## CHANGES FROM REL-1.00 to REL-2.00A

## CHANGES FROM REL-2.00A to REL-2.00B

Title *	Size: A4	Number:*	Revision:*	nbee Embedded Systems S.L. AV/Carlos V 45 4-D Móstoles (Madrid) 28938 SPAIN +34 91 1201798
Date: 03/01/2012	Time: 11:49:04	Sheet * of *		
File: Z:\clientes\nbee\modules\actel\microdevel\src\pcb\changelog.schdoc				 nbee embedded systems

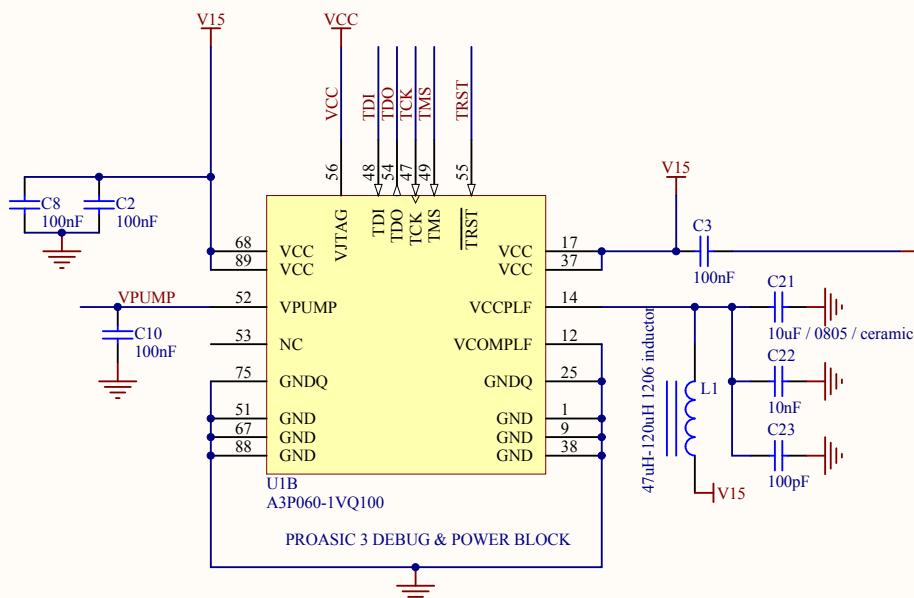
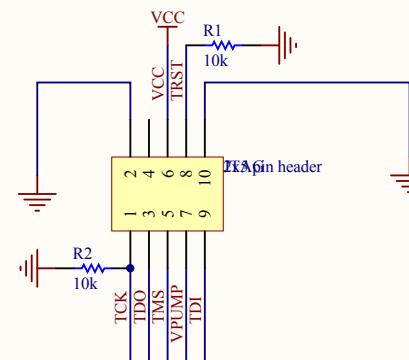
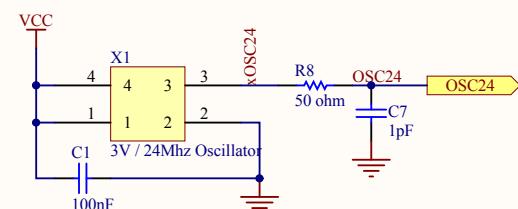
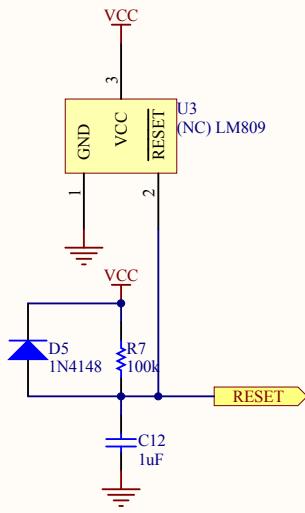
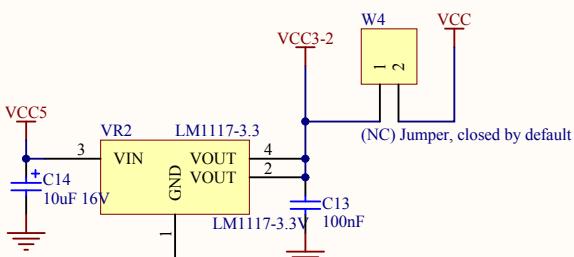
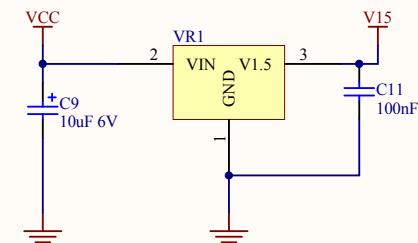
- \* All ceramic capacitors and resistors changed into 0603
- \* 50 Ohm + C at output of oscillator
- \* LM809 reset controller
- \* SW for leds removed
- \* C14 to 16V
- \* Add 100nF very close to vpump
- \* Jumpers for A3P250 compatibility on pin 46, 99 and 100 to GND
- \* 3.3V input/output to pin 14 of P1
- \* 10k Pull Down to TCK and TRST

- \* 47-120uH + 0.1nF + 10nF + 10uF filtering on PLL power input
